Terminology around DWDM systems and relation with ITU-T SG15 Recommendations. Author's understanding of outcome meetings 28 January & 4 February 2021

Peter Stassar, Huawei

IEEE P802.3ct Task Force, Terminology Ad Hoc Call, 12 February 2021

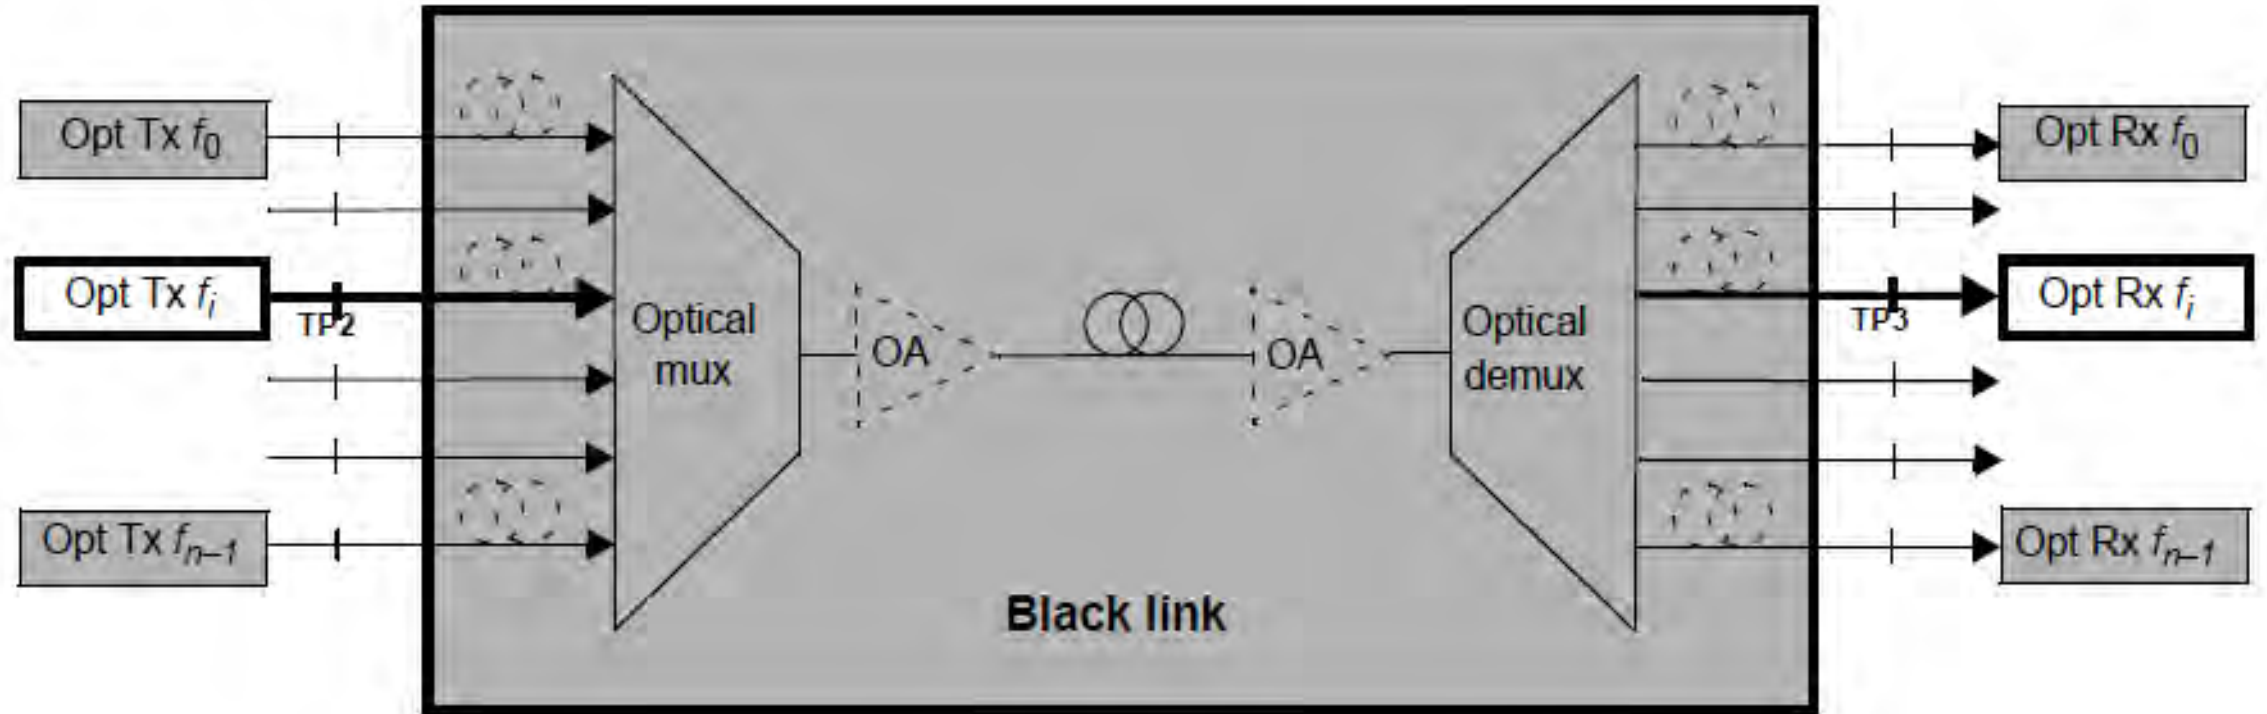
During the call on 28 January some concerns were raised on usage of term “black link” compared to the definition of “link” in IEEE Std 802.3™-2018.

1.4.302 link: The transmission path between any two interfaces of generic cabling. (From ISO/IEC 11801.)

This could be seen not inconsistent with a definition of DWDM black link between multiple TP2 and multiple TP3.

There seems to be no issue with general usage of link.

Figure 154-3—Black link example configuration for specifying n DWDM channels

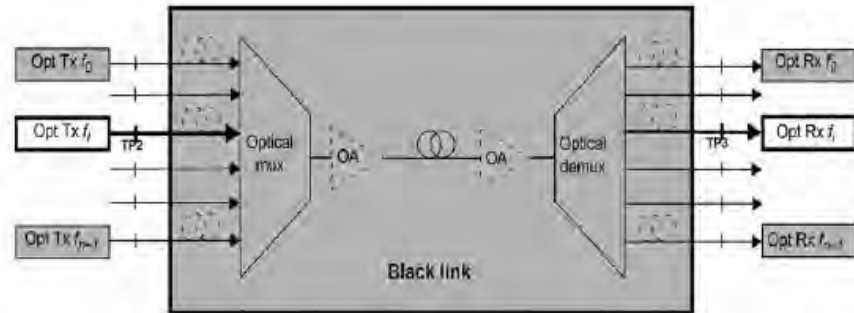
Concerns raised on Figure 154-3

- The focus of Figure 154-3 is when all signals are propagating on a single fiber in the same direction.
- It should be shown as a black box instead of a grey box and show the figure with the details in an informative annex.

- During the discussion on 4 February 2021 the concerns raised in [dambrosia 3ct 01 210204](#) and reproduced on the four previous slides were extensively discussed.
- Making the grey box black without details will be removing crucial information to understand what Clause 154 is about.
- Adding the proposed figures are only a small subset of all potential configurations. There are endless variations, especially in the case of bi-directional operation, where the proposed figure in [dambrosia 3ct 01 210204](#) shows a very particular choice of wavelength partitioning which may be adding more confusion than resolving.
- The purpose of Figure 154-3 is to show the location of single-channel reference points and give an insight of the functions inside the grey box.
- We could consider to see how far we get by adding notes to the text in subclause 154.6 and to Figure 154-3.

There seems to be no opposition to call the grey box in Figure 154-3 "DWDM black link".

- In line with comment / proposed remedy R1-2 (from the author):
Add "Furthermore bi-directional transmission over the multi-channel fiber inside the black link is not precluded." to the Note in 154.6 and additionally add "Bi-directional transmission over the multi-channel fiber inside the black link is not precluded" to Figure 154-3.
- Add further notes to the text in subclause 154.6 and to Figure 154-3 (similar to the note in Figure 154-2):
"Only one direction of transmission is shown. For communication between two 100GBASE-ZR PHYs two DWDM channels will be required - one DWDM channel in each direction of transmission. Inside the DWDM black link these two DWDM channels may be transported over a single optical fiber or a single fiber per direction."

Figure 154-x – Black Link Approach for specifying DWDM channels in a DWDM Link

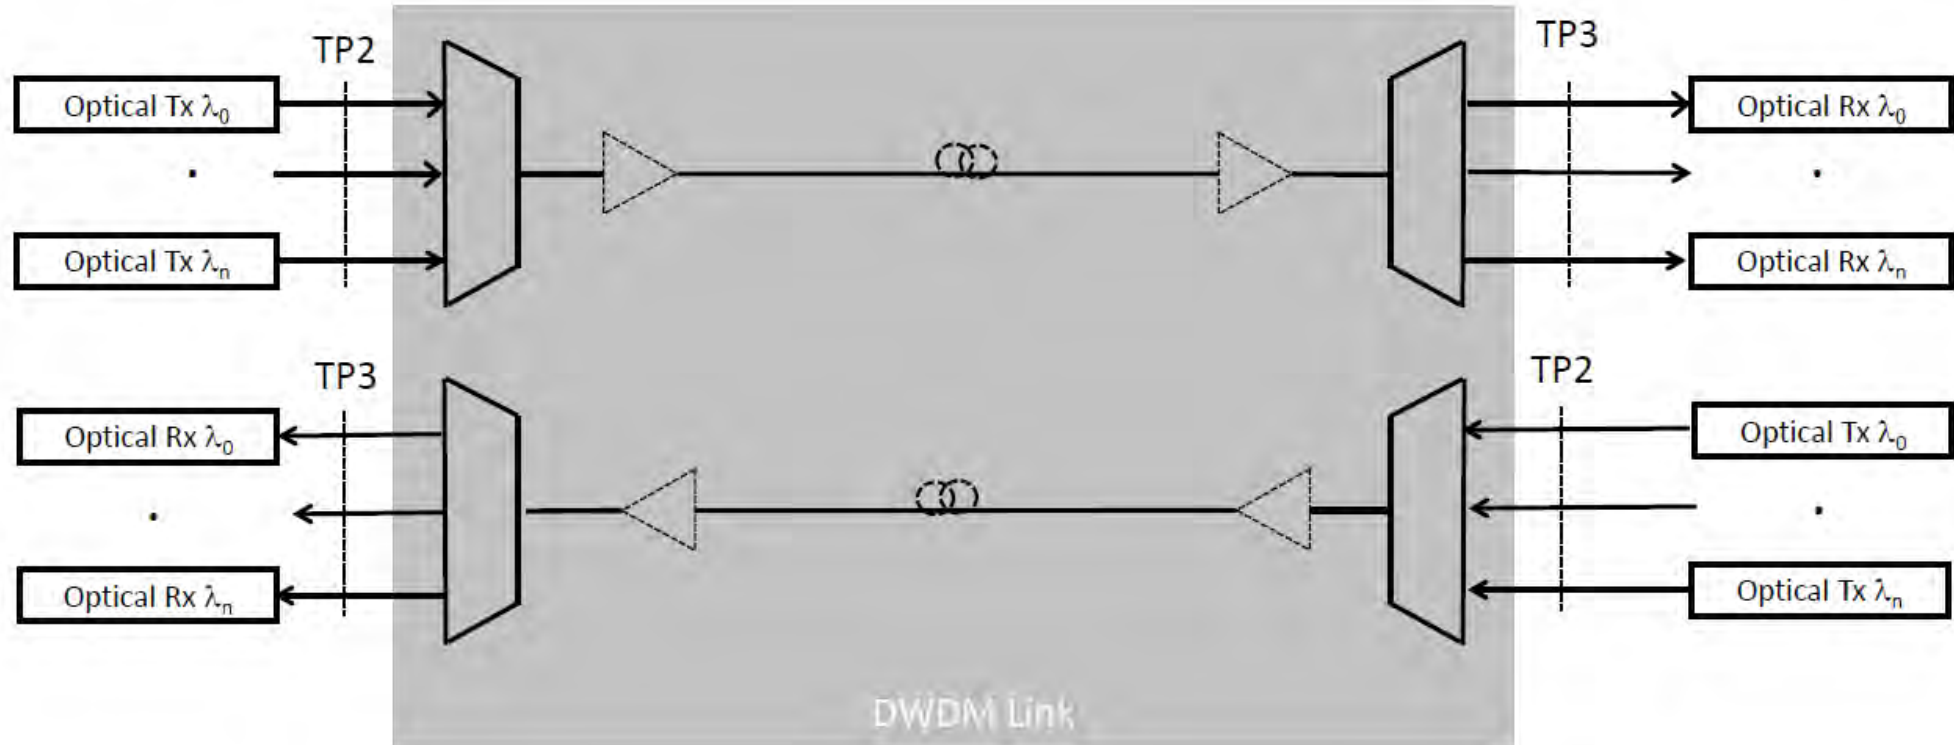
Concerns raised on Figure 154-3, continued

Need another figure illustrating an aggregate of DWDM channels over a single optical fiber (bi-directional transmission), where 50% of the signals go West-East and the other 50% go East-West (opposite direction).

Example - DWDM Link – Single Fiber Per Direction

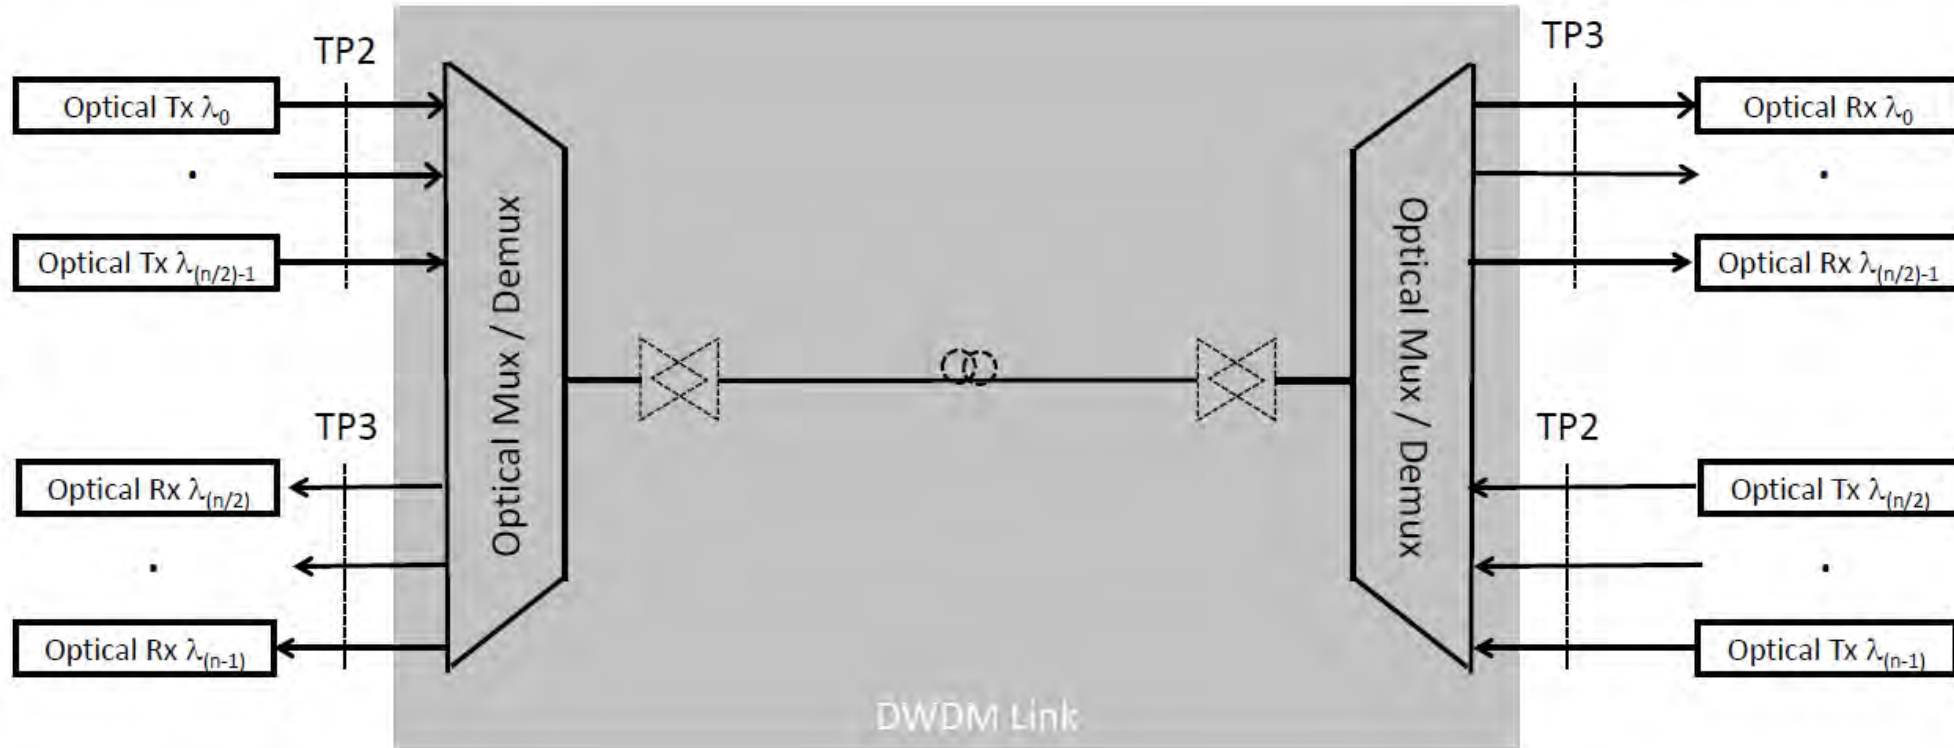
Concerns raised on Figure 154-3, continued

Add another Figure showing that to get a complete link both directions are needed.
